JV10-NL Block Diagram

Project code: 91.4HX01.001
PCB P/N : 48.4HX01.0SB
REVISION : SB

Title: **Modify History**

Date: Sunday, January 31, 2010 Sheet 42 of 42

Sheet 13 of 42

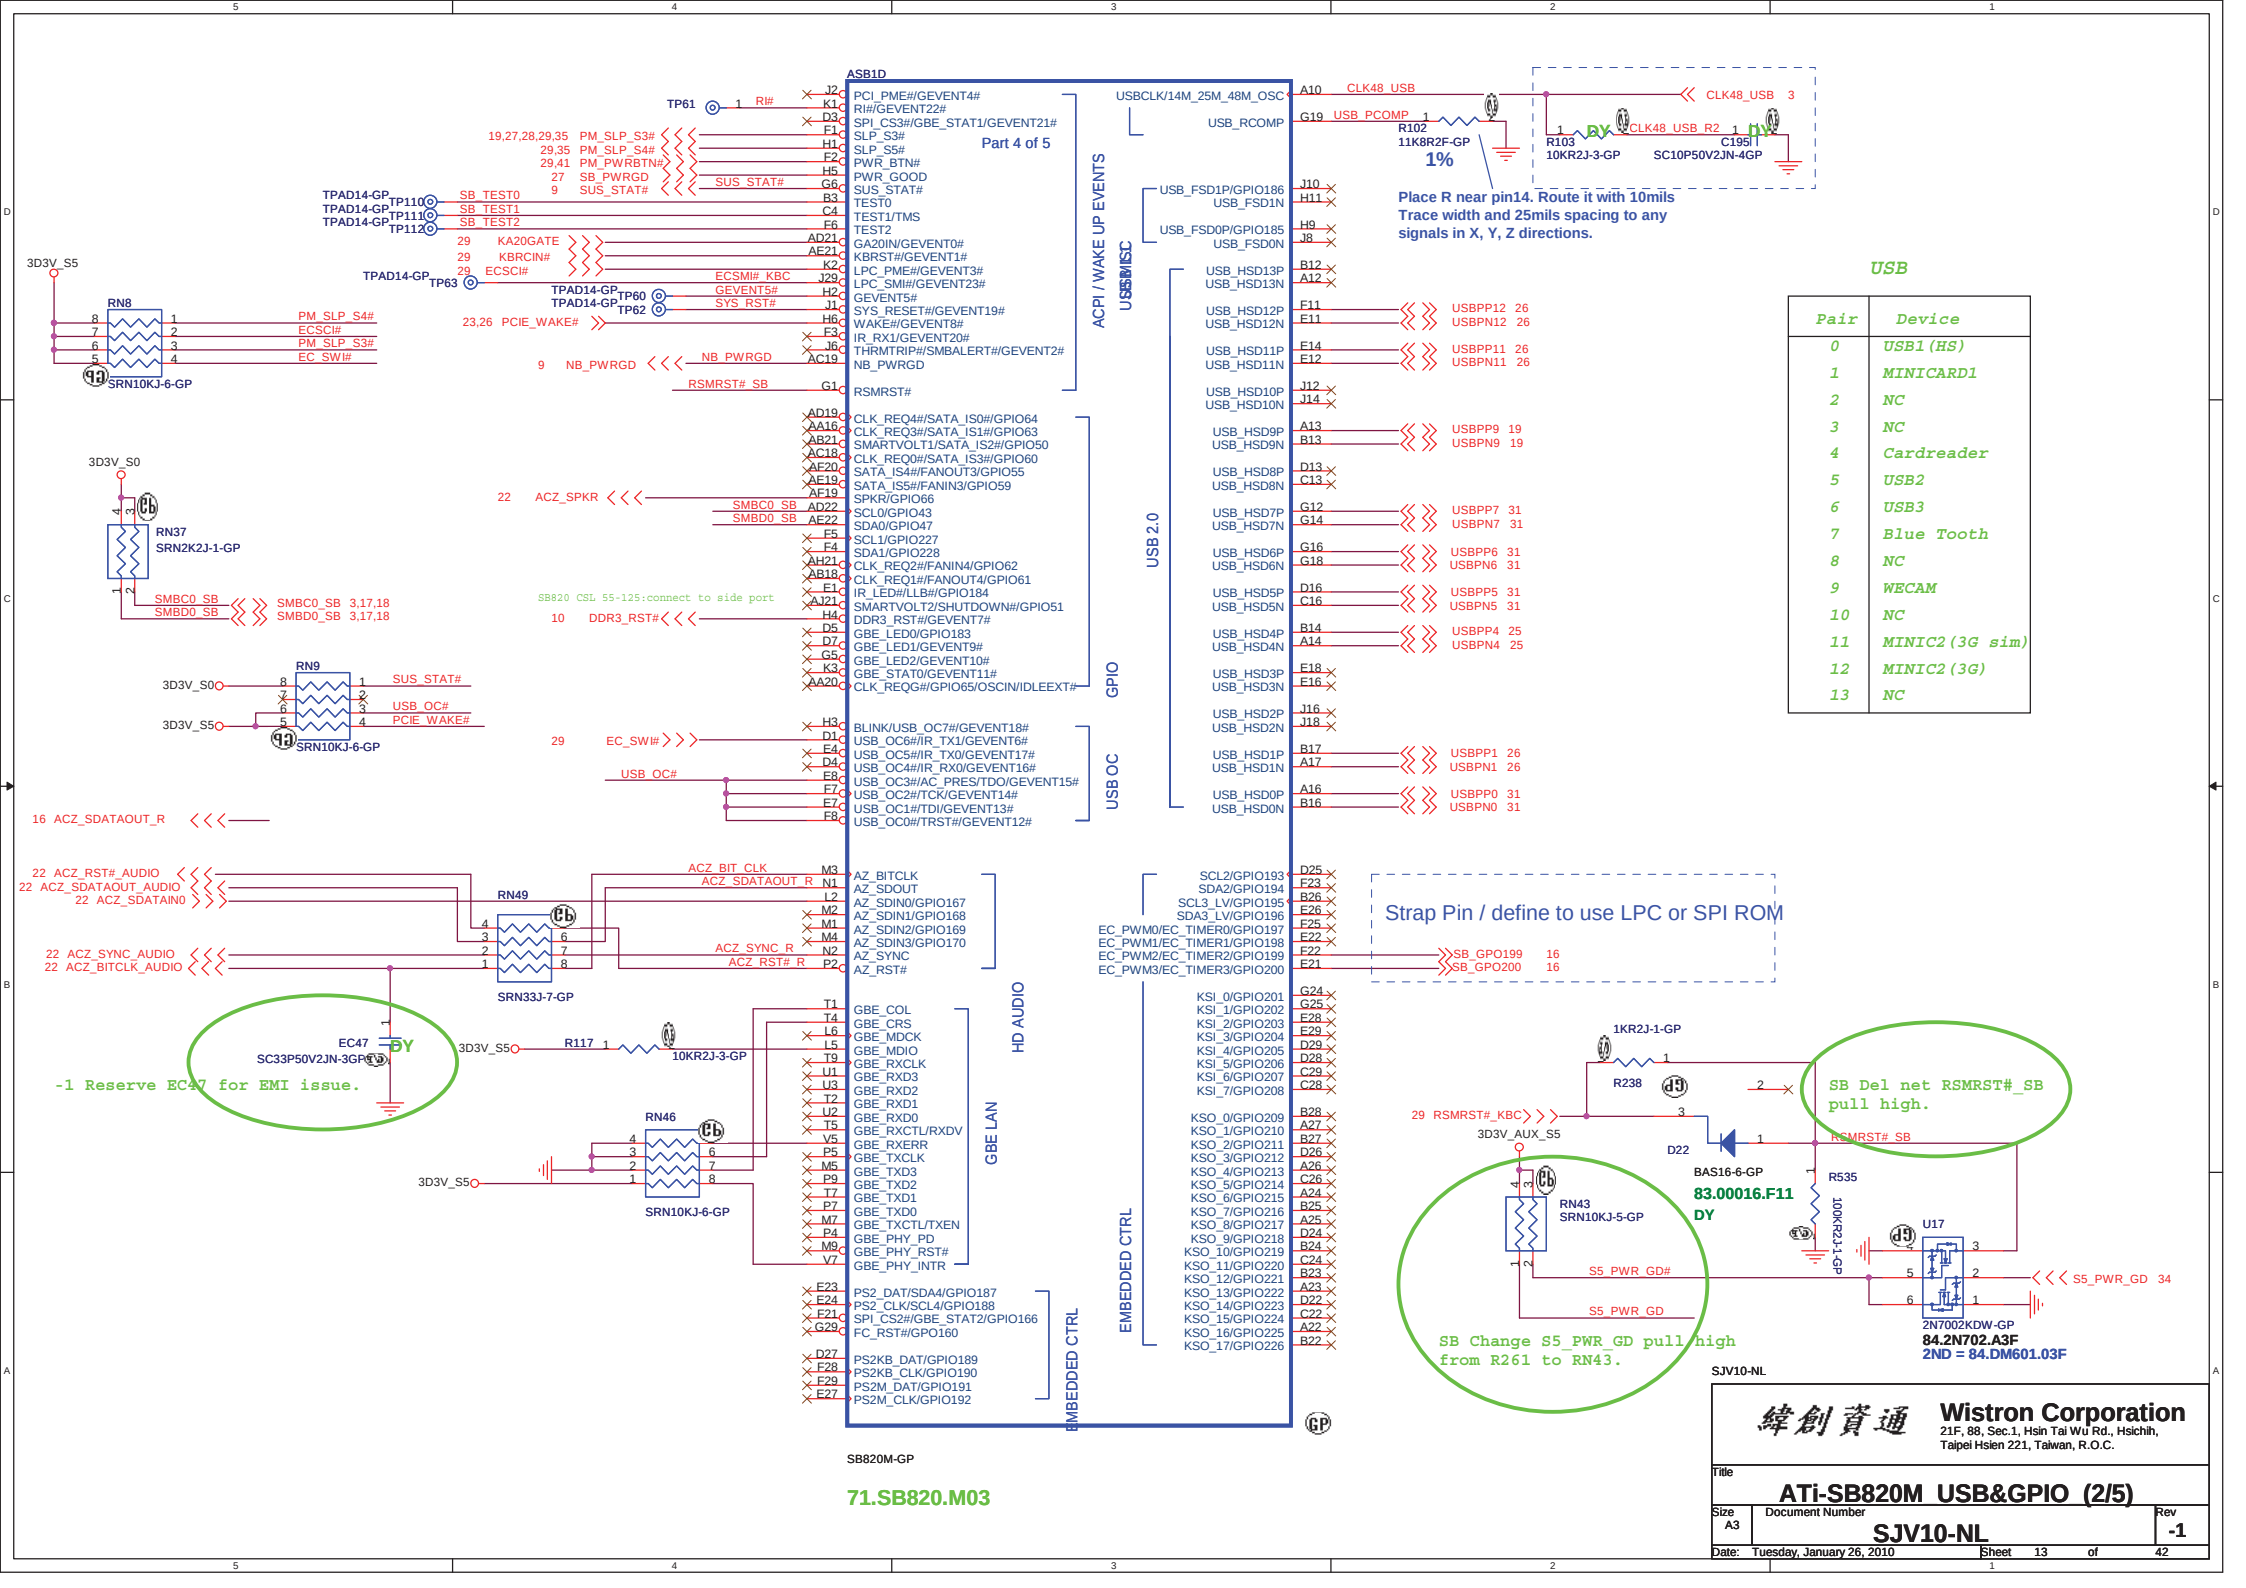
71.SB820.M03
TP61
TP110
TP111
TP112
TP63
TP60
TP62
RN8
SRN10KJ-6-GP
RN37
SRN2K2J-1-GP
RN9
SRN10KJ-6-GP
RN49
SRN33J-7-GP
RN46
SRN10KJ-6-GP
EC47
SC33P50V2JN-3GP
-1 Reserve EC47 for EMI issue.
R102
11K8R2F-GP
1%
R103
10KR2J-3-GP
C195
SC10P50V2JN-4GP
Place R near pin14. Route it with 10mils
Trace width and 25mils spacing to any
signals in X, Y, Z directions.
R117
10KR2J-3-GP
SB820 CSL 55-125:connect to side port
Strap Pin / define to use LPC or SPI ROM
SB_GPO199 16
SB_GPO200 16
1KR2J-1-GP
R238
D22
BAS16-6-GP

83.00016.F11
DY
R535
100KR2J-1-GP
RN43
SRN10KJ-5-GP
U17
2N7002KDW-GP
84.2N702.A3F
2ND = 84.DM601.03F
SB Del net RSMRST#_SB
pull high.
SB Change S5_PWR_GD pull high
from R261 to RN43.
USB
Pair | Device
0 | USB1(HS)
1 | MINICARD1
2 | NC
3 | NC
4 | Cardreader
5 | USB2
6 | USB3
7 | Blue Tooth
8 | NC
9 | WECAM
10 | NC
11 | MINIC2(3G sim)
12 | MINIC2(3G)
13 | NC
SJV10-NL
緯創資通
Wistron Corporation
21F, 88, Sec.1, Hsin Tai Wu Rd., Hsichih,
Taipei Hsien 221, Taiwan, R.O.C.
Title
ATi-SB820M USB&GPIO (2/5)
Size A3
Document Number SJV10-NL
Rev -1
Date: Tuesday, January 26, 2010

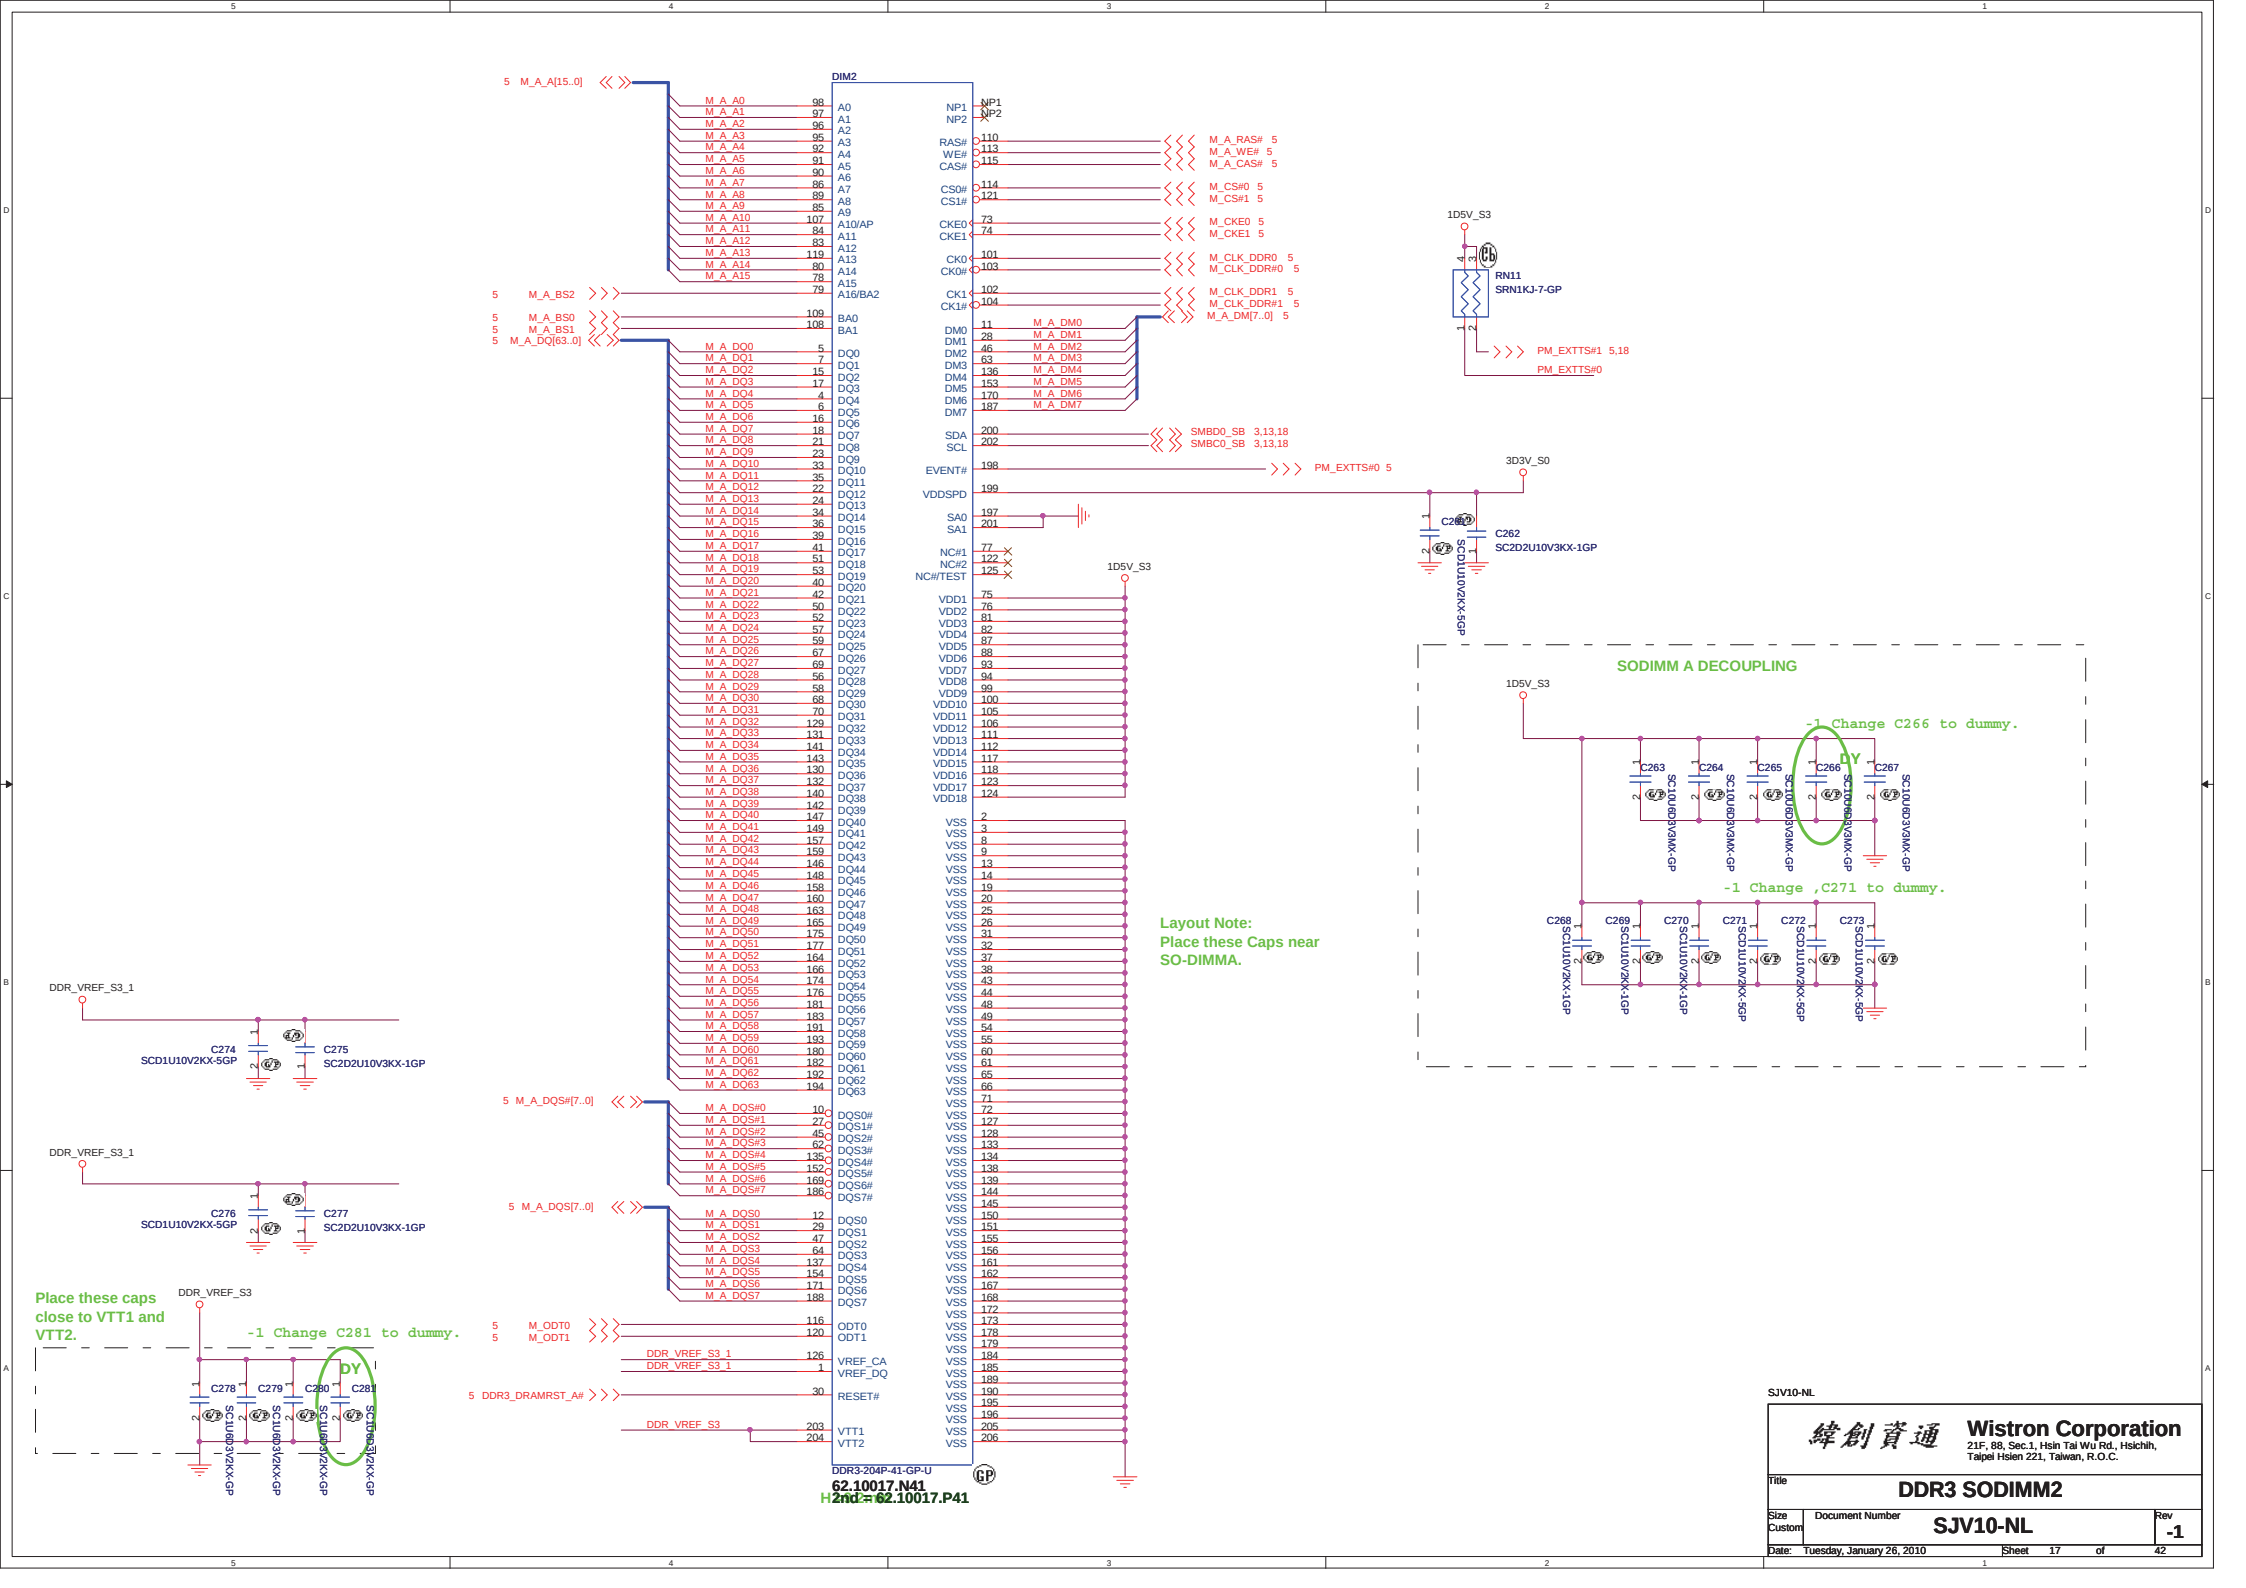
DIM2
DDR3-204P-41-GP-U
62.10017.N41
2nd = 62.10017.P41
SODIMM A DECOUPLING
-1 Change C266 to dummy.
-1 Change ,C271 to dummy.
Layout Note:
Place these Caps near
SO-DIMMA.
Place these caps
close to VTT1 and
VTT2.
-1 Change C281 to dummy.
RN11
SRN1KJ-7-GP
C262
SC2D2U10V3KX-1GP
C274
SCD1U10V2KX-5GP
C275
SC2D2U10V3KX-1GP
C276
SCD1U10V2KX-5GP
C277
SC2D2U10V3KX-1GP
1D5V_S3
3D3V_S0
DDR_VREF_S3_1
DDR_VREF_S3
PM_EXTTS#1 5,18
PM_EXTTS#0
SMBD0_SB 3,13,18
SMBC0_SB 3,13,18
M_A_RAS# 5
M_A_WE# 5
M_A_CAS# 5
M_CS#0 5
M_CS#1 5
M_CKE0 5
M_CKE1 5
M_CLK_DDR0 5
M_CLK_DDR#0 5
M_CLK_DDR1 5
M_CLK_DDR#1 5
M_A_DM[7..0] 5
M_ODT0
M_ODT1
DDR3_DRAMRST_A#
Wistron Corporation
21F, 88, Sec.1, Hsin Tai Wu Rd., Hsichih,
Taipei Hsien 221, Taiwan, R.O.C.
DDR3 SODIMM2
SJV10-NL
-1
Tuesday, January 26, 2010
17
42

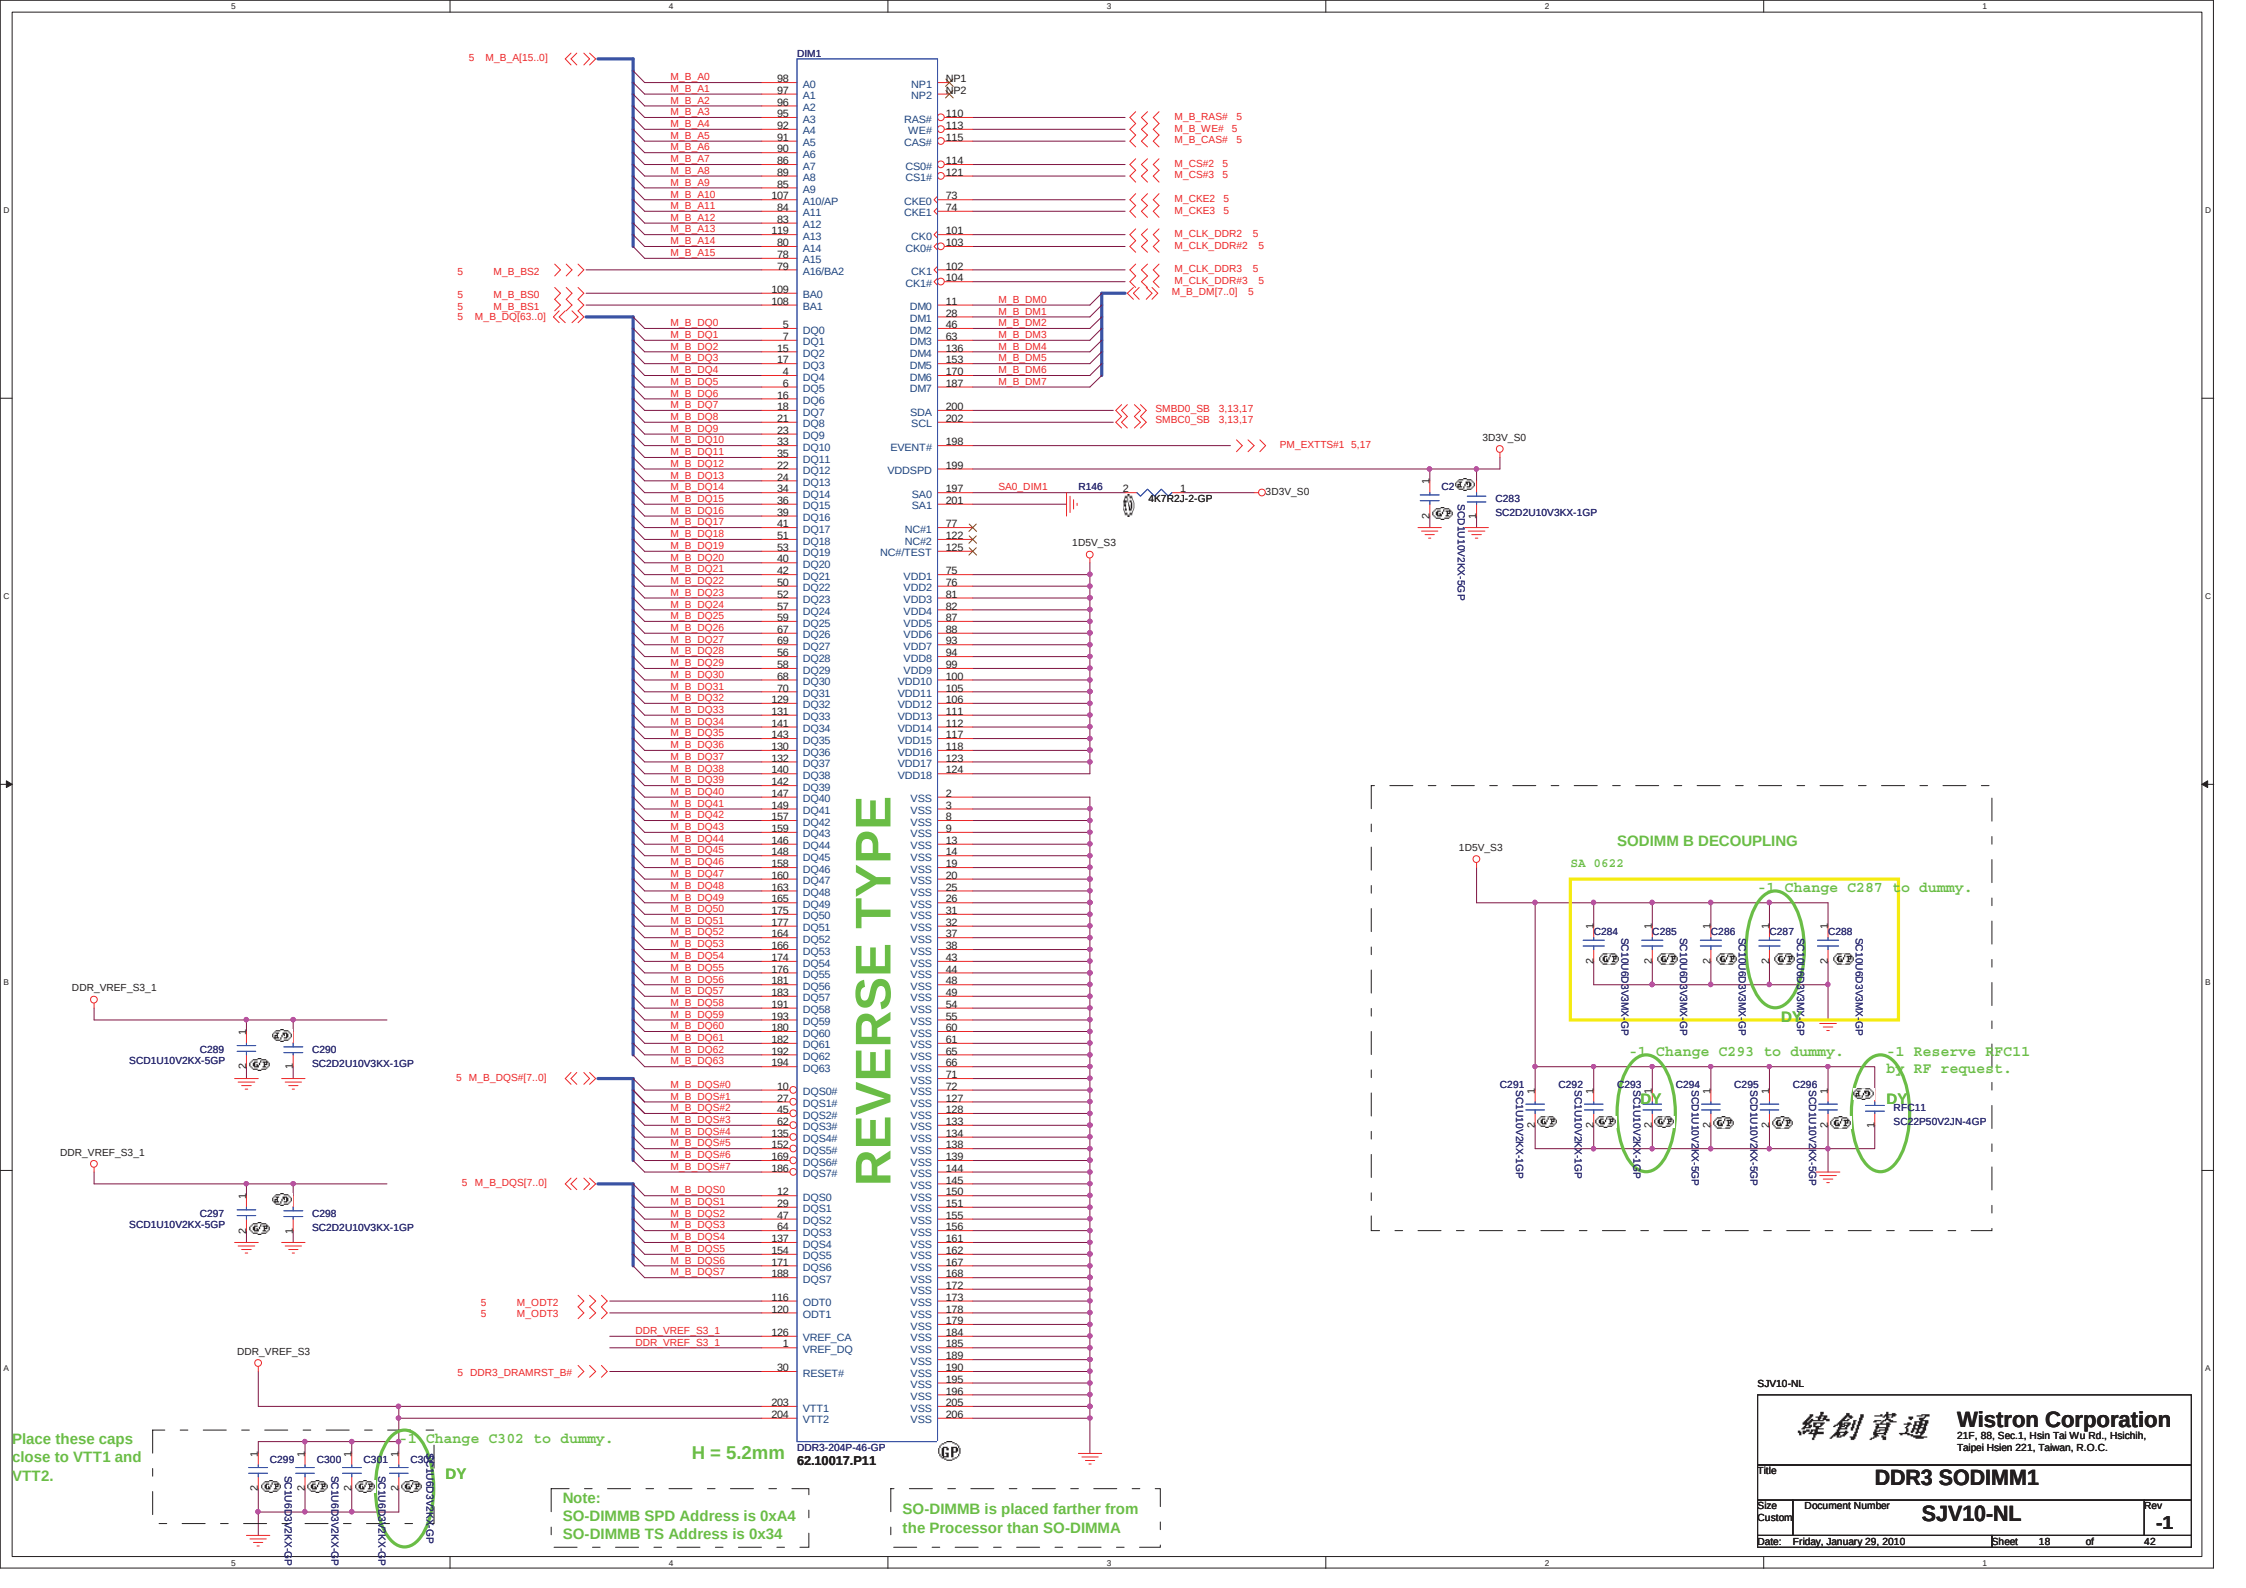
DIM1
REVERSE TYPE
DDR3-204P-46-GP
62.10017.P11
SODIMM B DECOUPLING
SA 0622
-1 Change C287 to dummy.
-1 Change C293 to dummy.
-1 Reserve RFC11 by RF request.
-1 Change C302 to dummy.
Place these caps close to VTT1 and VTT2.
H = 5.2mm
Note:
SO-DIMMB SPD Address is 0xA4
SO-DIMMB TS Address is 0x34
SO-DIMMB is placed farther from the Processor than SO-DIMMA
SJV10-NL
Wistron Corporation
21F, 88, Sec.1, Hsin Tai Wu Rd., Hsichih,
Taipei Hsien 221, Taiwan, R.O.C.
DDR3 SODIMM1
SJV10-NL
-1
Friday, January 29, 2010
18
42
